CMRI Gene Technologies Building

STATE SIGNIFICANT DEVELOPMENT APPLICATION: SSD-45576956 RESPONSE TO SUBMISSIONS – TRAFFIC AND TRANSPORT

Figure 1: Parking Availability

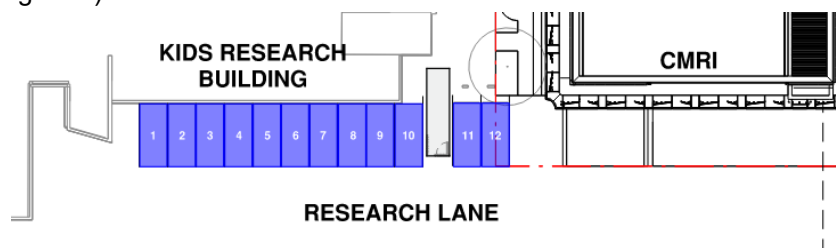
Comment: Part 6.6 of the EIS states that eight car parking spaces on the site are being removed and 12 offsite spaces will be reduced to 11. However, Part 3.5.2 of the Transport and Accessibility Impact Assessment states that 11 car parking spaces will be removed and nine car parking spaces will be retained upon completion. The Demolition – Phase B L2 Ground drawing seems to show removal of three car parking spaces in Research Lane. Please provide clarification.

Response: For clarity, the SSD works will result in a net reduction of 7 spaces along Research Lane. The latest design plans indicate that, out of the existing 19 parking spaces along Research Lane (previously 20 spaces prior to the water meter installation under a separate planning approval), a total of 12 spaces will be retained: 10 spaces adjacent to the Kid's Research building, and 2 spaces adjacent to the courtyard. The 7 angled spaces currently located beside the proposed CMRI development will be lost as a result of the future loading dock, which is proposed at such location.

Refer to the latest demolition plan prepared by Hassell (drawing no. DA_0101 [rev. D], dated 14 August 2025) which illustrates the latest carparking availability along Research Lane upon completion of construction (see Figure 1).

Figure 2: Updated Car Park Layout

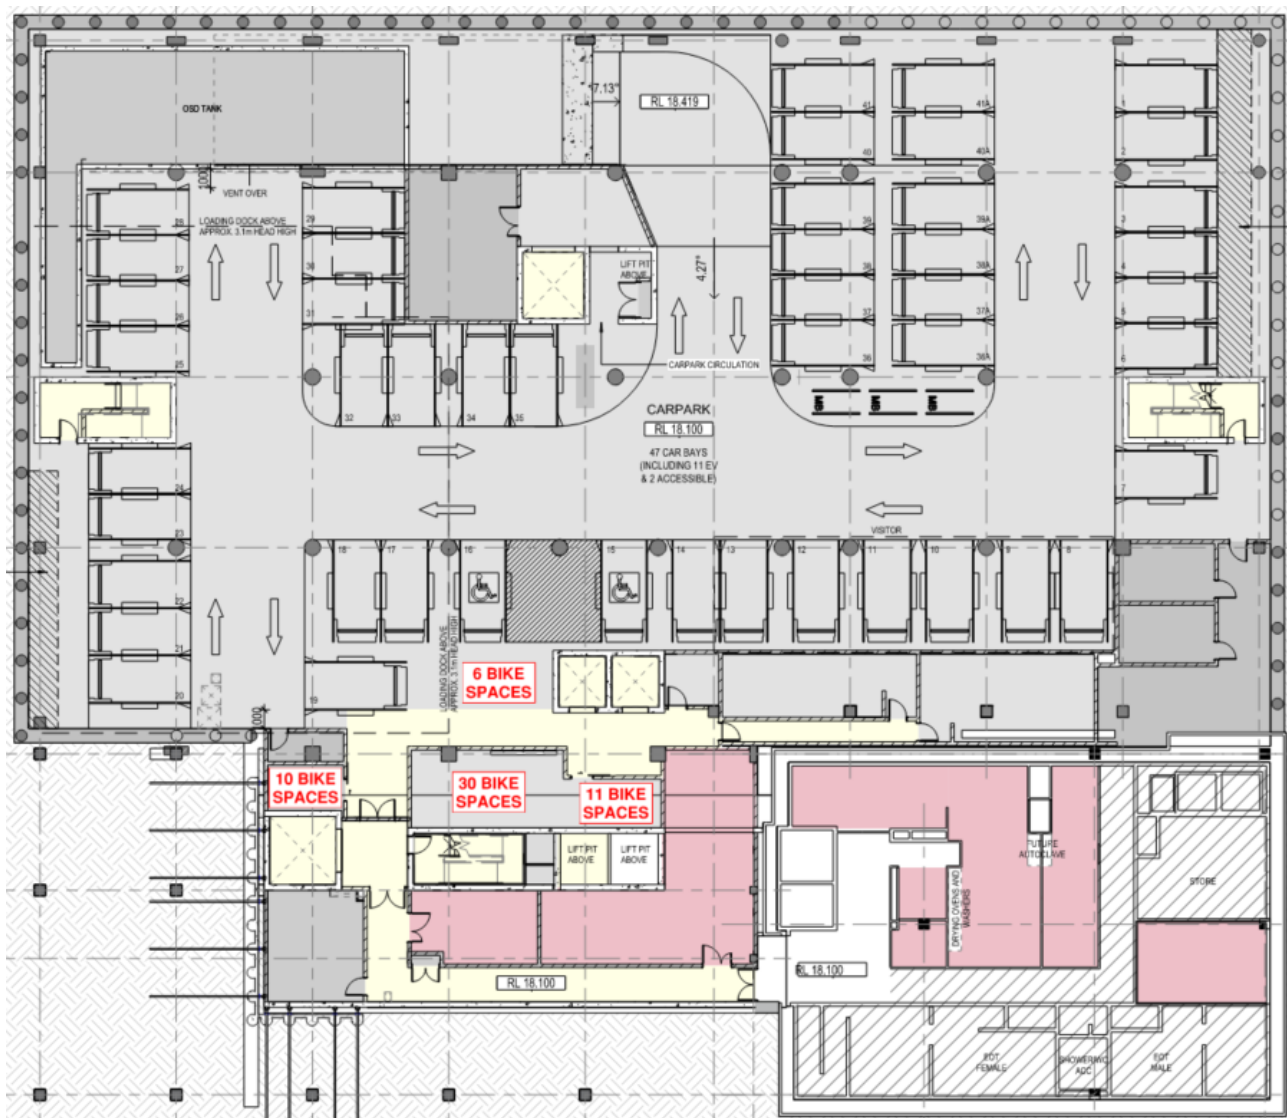
- **Required: 111 spaces**
- **Proposed: 58 spaces**
- **Comment: Non-compliance with DCP; recommendation to increase to 111 to support active transport and support under-provision of car parking.**

- **Required: 1 space**
- **Proposed: 0 spaces**
- **Comment: Space available to provide; recommend a condition be imposed requiring it.**

Comment: The blind aisle extension next to parking spaces No. 1 and 47 does not comply with the requirements of AS 2890.1 which requires at least 1m to be provided for access to and from the spaces. Further, the column next to space no. 47 encroaches the design envelope as per figure 5.2 of AS 2890.1. However, it is noted that the width of parking spaces is 2.5m whereas staff parking can be reduced to 2.4m. Accordingly, the plans should be amended to reduce the width of spaces No. 1, 45, 46, and 47 to 2.4m to allow for at least a 1m blind aisle extension. Similarly, it is noted that columns are obstructing the design envelope for the parking spaces Nos: 6, 26, 31 and 34 which will need to be addressed. Meeting these requirements should not impact any structural elements of the car park and can be conditioned.

In response, additional bicycle facilities have been provided, the updated proposal currently provides a total of 65 spaces. The revised basement level provides a total of 57 spaces, along with the existing 8 spaces at the Ainsworth tower. Figure 2 shows the indicative locations of the proposed bicycle parking.

Response: Motorcycle spaces have been integrated into the proposed development in accordance with AS 2890, refer to the departmental plan (*drawing no. DA_1200 [rev. C], dated 15 July 2025*) which shows 3 motorcycle spaces integrated into the basement carpark (see Figure 2).

Response: The above items have been rectified, as shown below in Figure 2.

Figure 3: Pedestrian Access Route

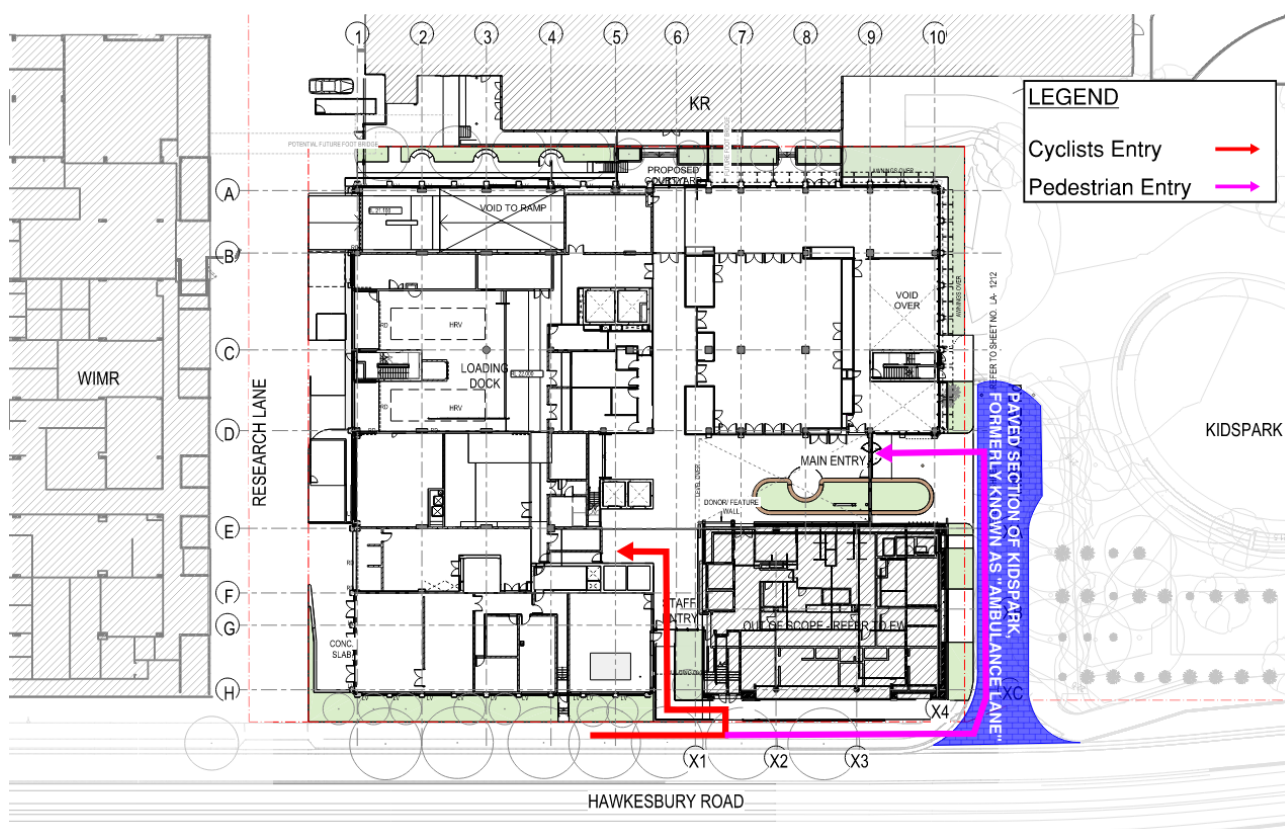
Comment: *It is not clear how the building and its entrances integrate with the wider health precinct. For example, the report talks about pedestrian access via Ambulance Lane, but it is not clear what Ambulance Lane looks like from the report. Similarly, it is expected that cyclists coming from the east will access via Research Lane, but it is not clear how cyclists from north, or from the Health precinct, access the site. There should be good active transport connectivity to the Health precinct.*

Response: “Ambulance Lane” in the report refers to the road between the proposed CMRI and KIDSPARK, as illustrated in Figure 3. However, it is understood that this is no longer the case, the road is now simply known as the paved section of the KIDSPARK, with removable bollards in place for occasional vehicle access if required. Figure 3 below shows the pedestrian access route from Hawkesbury Road to the main entry of CMRI.

As there is currently no dedicated bicycle access lane at the car park entrance on Research Lane, cyclists from all directions are required to dismount and enter via the “Staff Entry”, similar to the access path shown in Figure 3. Similarly, pedestrians approaching from all directions are expected to access the main entry of CMRI through the paved section of KIDSPARK.

Figure 4: Research Lane Driveway Crossover Modification (indicative only)

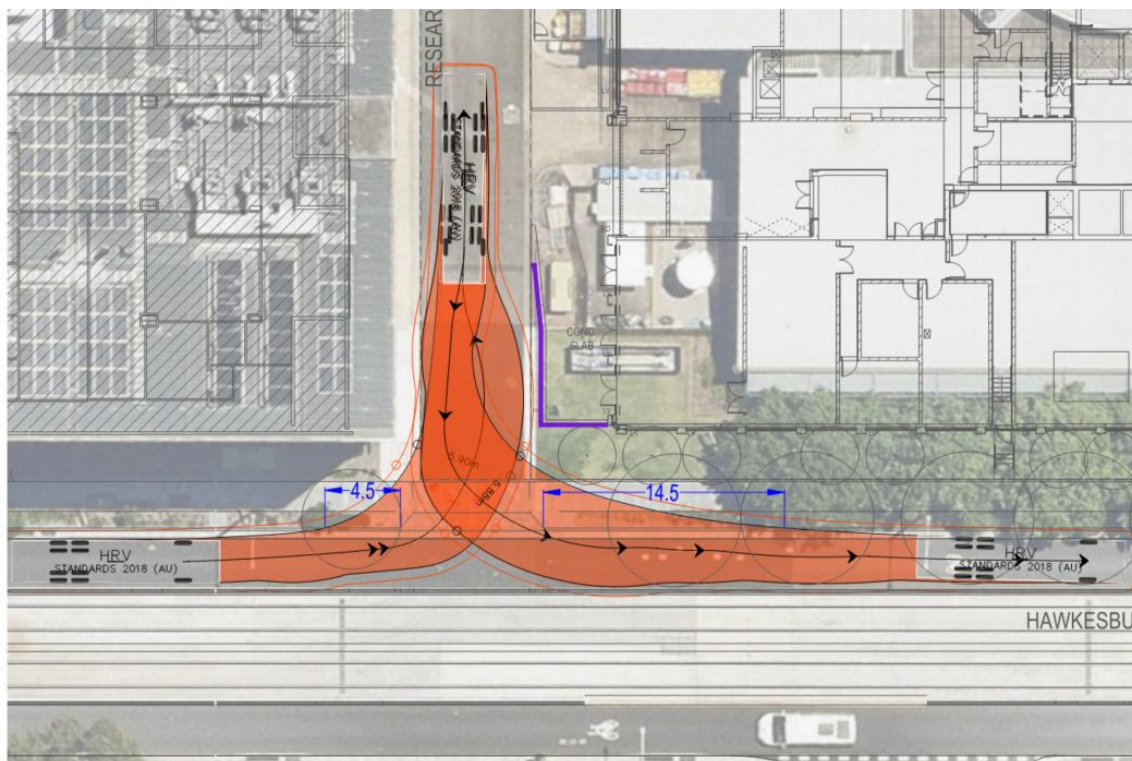
Comment: Swept paths for Heavy Rigid Vehicles (HRV) are shown to cross the deterrent kerbs for the light rail tracks for both access and egress movements at the intersection of Hawkesbury Road and Research Lane.

Comment: Swept paths for the heavy rigid vehicles (HRV) are shown to conflict with the proposed kerbs on Research Lane outside the new loading dock for both ingress and egress movements.

Response: TTW acknowledges the need for a driveway modification at the Hawkesbury Road – Research Lane intersection, to ensure the 12.5m heavy rigid vehicle turning path stays completely clear of the adjacent light rail corridor. In response to TfNSW's comment, the driveway crossover at Research Lane will be widened post-approval to achieve the above, Figure 4 indicatively illustrates the extent of the driveway modification. Consultation with the civil engineers and architects has confirmed that such a modification is feasible. The detailed design of the modification, including all relevant elements, will be updated and incorporated as part of the driveway works post-SSDA. DPHI may include such requirement as a condition of consent should it be deemed necessary.

Response: As noted in the preceding comment, certain medical consumables required at CMRI necessitate the use of HRVs to service the site. Accordingly, the kerb design will be modified to eliminate any existing conflicts between the HRV turning path and the adjacent light rail corridor, as shown in Figure 4.
